**STAFF REPORT - DESIGN REVIEW E
FINDINGS AND RECOMMENDATION**

FILE NUMBER: DRE/LL/VAR/TR 20-26000001 - Albertina Kerr Workforce Housing

PROPOSAL: Type III Design Review E for the construction of a four-story, 150-unit apartment building with parking, a children's play area, a storage building, and other associated site improvements, a Type III Major Variance to the parking regulations, a Type II Minor Variance to the maximum building height, a Type II Tree Removal, and a Type I Lot Line Adjustment.

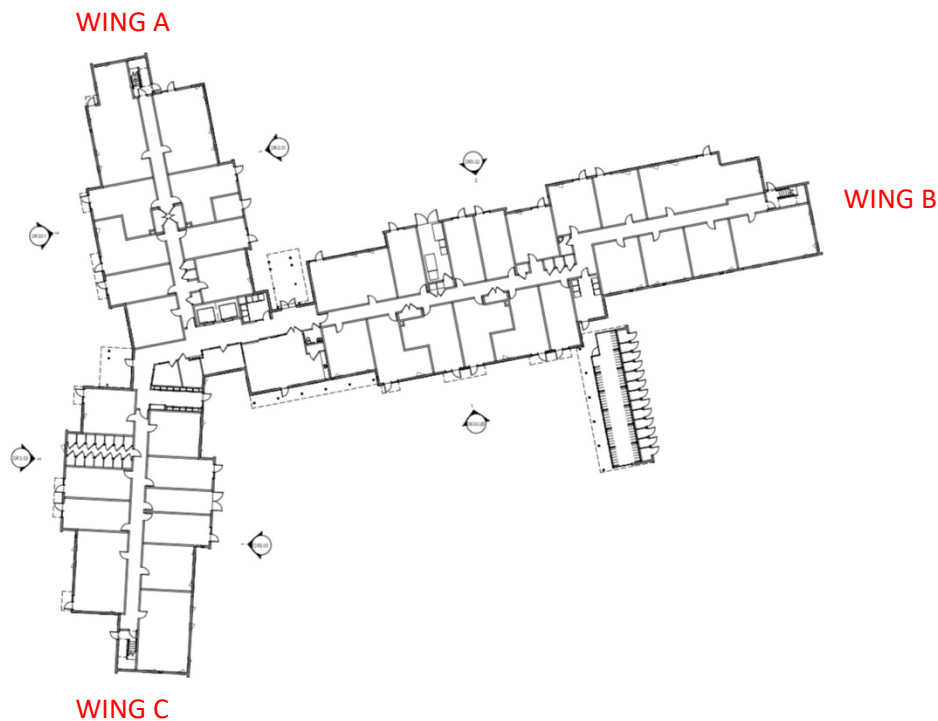
6.0010 - Lot Arrangement. This standard requires that there be no foreseeable difficulties in securing building permits to build on all lots in compliance with the Gresham Development Code. Per Sheet C0.30 - Preliminary Lot Line the proposed south property line overlaps a portion of the existing north Chapel wall. Per Sheet C0.32 - Preliminary Lot Line, the south property line appears to be a minimum of 3.5 feet from the north façade of the existing Chapel. The proposed south lot line also appears to overlay proposed carports. In order to follow the building code, a 10-foot distance or other distance approved by the Building Department is required between structures and the adjusted south property line.

Survey Map. The proposed lot line adjustment is a Type I procedure, which is being processed with the project's design review application. All applicable requirements of the Community Development Code apply and are evaluated in the applicant's narratives and this Staff Report. The applicant shall submit a final survey map and adjusted legal descriptions. The final map shall comply with the approved preliminary plan and shall comply with the applicable requirements of ORS Chapters 92 and 209. The approved final map, along with the deeds transferring ownership, must be recorded with Multnomah County Deed Records.

This standard is met with Condition of Approval #5.

Local Transitional Street:

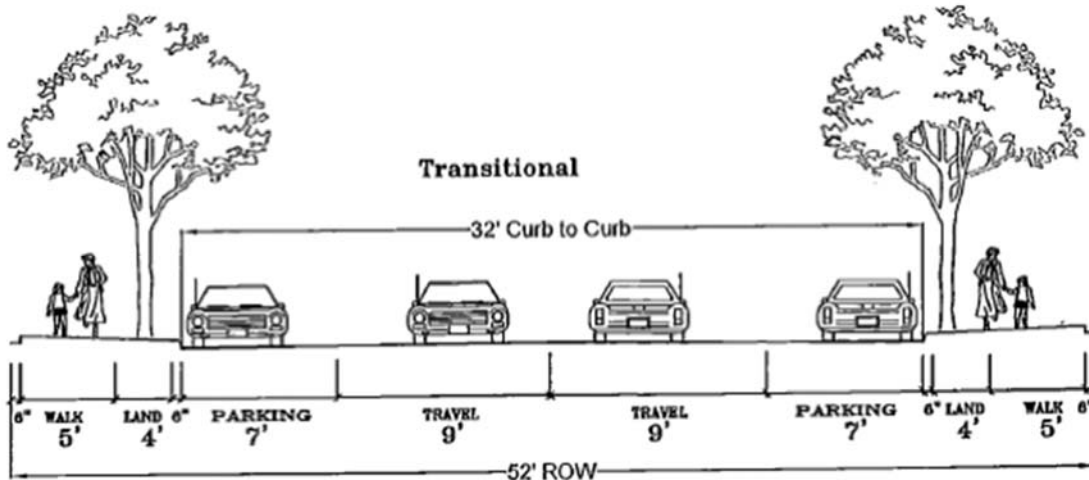
NE Holladay Street is classified as a Local Transitional Street, requiring 26 feet of right of way to centerline. There is currently 25 feet of right of way to centerline along the NE Holladay Street frontage. To meet standards for a Local Transitional Street, a dedication of an additional 1-foot is needed along the NE Holladay Street frontage. The applicant is showing the 1-foot dedication in drawing C0.30, which meets the standard.

Gresham Public Works Standards 6.02.11 requires additional dedications of right of way at intersection corners along the long chord, based on the curb return radius of the lowest classification street at the intersection. A corner dedication at the intersection of NE 162nd Avenue and NE Holladay Street is needed to meet standards. The applicant is showing a corner dedication in drawing C0.30. The lines appear to show some existing right of way returning to the applicant, which is not possible. The corner dedication needs to use the existing right of way and come as close as possible to meeting the standard.
